CALIFORNIA COASTAL COMMISSION

REGULAR CALENDAR
STAFF REPORT AND PRELIMINARY RECOMMENDATION

Application No.: 6-06-152

Description: Construction of an outlet pipe within an existing riprap revetment located on Buccaneer Beach in association with the development of a filtration and ultraviolet irradiation storm water treatment facility adjacent to Loma Alta Creek.

EXHIBIT NO. 4
APPLICATION NO.
6-06-152
Endfall as Proposed

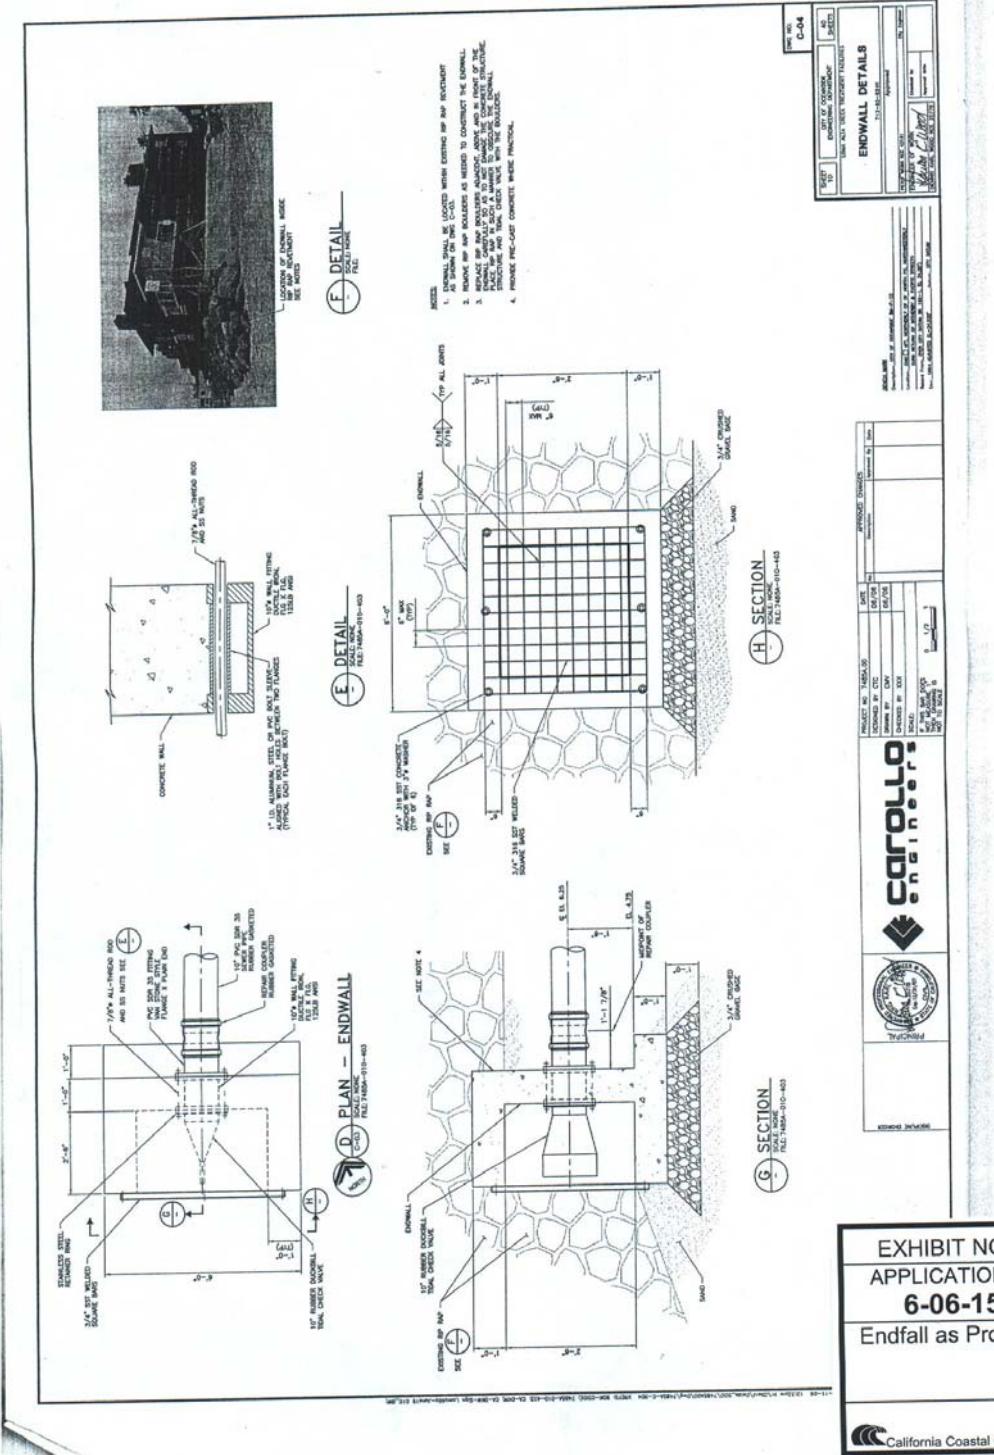
- b. Plans indicating the reconstructed riprap revetment will be constructed to minimize impacts to public access. Plans shall incorporate any modification to the riprap that will decrease the revetment footprint while still protecting the outfall pipe and the neighboring condominium building, including seaward and southern extent of the existing revetment.
- c. Plans indicating the proposed apron no larger than 6'x 6' and located no less than 10' inland of the revetment footprint.

Because of frequent wave action, some protection for the discharge pipe and outfall structure was recommended by the wave runup analysis. As recommended, the outfall structure includes a 6 ft. by 6 ft. concrete apron to be constructed down into the beach sand. This concrete apron will serve as a scour guard to prevent the outfall structure from being undermined by wave action. The endwall, as submitted by the applicant, did not include the reinforcing apron (ref. Exhibit #4). Staff requested the applicant conduct a wave runup analysis. The wave runup analysis recommended the endwall incorporate a concrete apron to increase the strength and stability of the discharge pipe and endwall structure. Special Condition #1 therefore requires the applicant to submit final plans reflecting the recommendations of this wave runup analysis. Further, should site conditions warrant changes to these recommendations, Special Condition #11 requires the applicant to contact the San Diego office. Therefore, as conditioned, the geologic stability of the outfall has been properly addressed.

1. **Final Plans. PRIOR TO THE ISSUANCE OF THE COASTAL DEVELOPMENT PERMIT,** the applicant shall submit for review and written approval of the Executive Director, final plans in substantial conformance to the plans submitted by Carollo Engineers dated 12/11/06 with the following modifications:

EXHIBIT NO. 5
APPLICATION NO.
6-06-152
Endwall as
Recommended by
Wave Runup Anls.

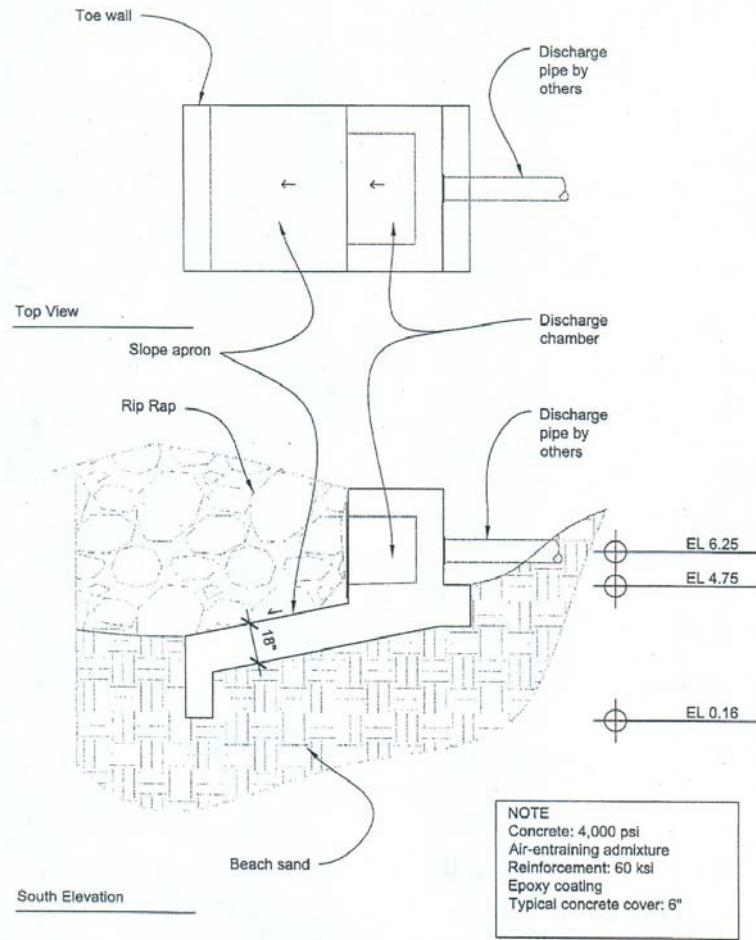
The outfall pipe will be protected by two revetments (west and south). Under large wave storm conditions, some of the beach sand in front of the west revetment may be exposed. However, this revetment will be able to withstand the effects of such wave events. The revetment consists of several layers of stones, which would reduce the effects of pore pressure on the sand behind the revetment. In addition, the foundation of the outfall pipe is concrete with a front wall [ref Exhibit #5] to prevent any possibility of scour occurring under the structure.

- a. The outfall structure shall be constructed in substantial conformance with the design recommended by The Loma Alta Creek Ultra Violet Treatment
